Revised Proposal for Regulation No 28 of the Economic Commission for Europe of the United Nations (UN/ECE) — Uniform provisions concerning the approval of audible warning devices and of motor vehicles with regard to their audible signals

The text reproduced below was prepared by the experts from Turkey based on GRB-64-05. The modifications are highlighted in yellow.

Incorporating all valid text up to:

Figure 1

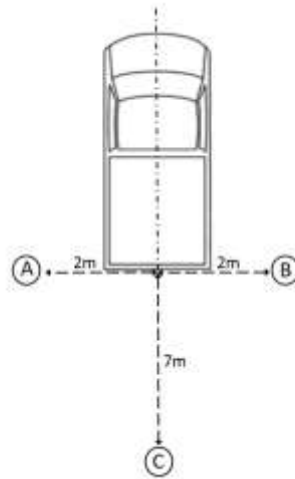
14.4.2. RAWDs class III and class IV shall be measured from the rear plane of the vehicle on A, B, C points as shown in Figure 1

14.9. Measured under the conditions specified in paragraphs 14.2 to 14.7, the maximum sound-pressure level (14.7) of the audible signal tested of RAWDs of class III shall be between the limits prescribed in Table 1. at least:

Measurement Positions	Limit Values of Vehicle Categories (dB(A))	
	[N2], [M2], M3	N3
A / B	[74 - 86]	[80 - 92]
C	[64 - 78]	[70 - 84]

MODEL A

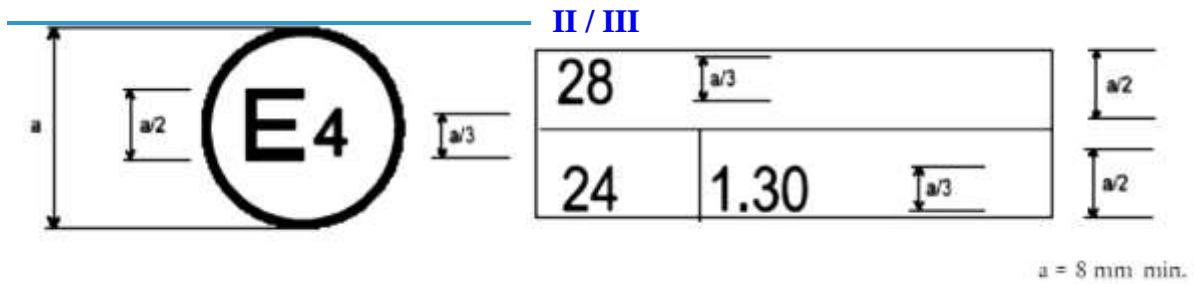
The above approval mark affixed to a vehicle indicates that, pursuant to Regulation No 28, this vehicle type has been approved in the Netherlands (E 4), with regard to its audible signals [according to class II \(horn\) and III \(reverse alarm\)](#).
